### 7.0 SOIL RESOURCES RESPONSES

## 7.1 Appendix B (g)(15)(A)

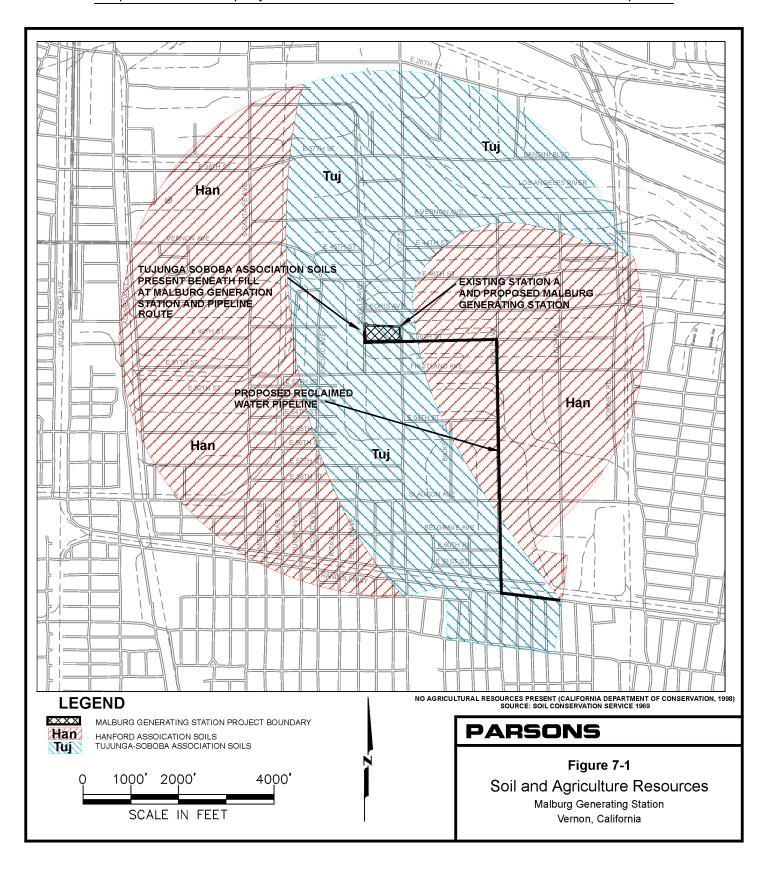
Please provide a map at a scale of 1:24,000

A map was included as Figure 8.9-1 in the AFC identifying the types of soils in the area. Descriptions of these soil types were provided in Section 8.9.1.2 on page 8.9-2. The project area is mainly industrial with no agricultural land uses. Therefore, no agricultural land will be affected by the MGS Project. Additional information is provided below regarding the soil types in the area and the effects on agricultural land uses. Figure 8.9-1 in the AFC is presented again as Figure 7-1 in color to better identify the soil types.

Two soil survey maps were prepared for the Los Angeles area in 1903 (Mesmer, 1903) and in 1919 (Nelson, et al, 1919). A "Report and General Soil Map for Los Angeles County" was also published in 1969 by the U. S. Department of Agriculture Soil Conservation Service (USDA, 1969). The small-scale map presented in this report shows that the soils in the site area are of either Hanford or Tujunga-Soboba series. The soil unit boundaries from this map, which should be considered approximate, were transferred to a 1:24000 topographic base map and are presented in Figure 7-1. The soil series north of the MGS site is Ramona-Placentia.
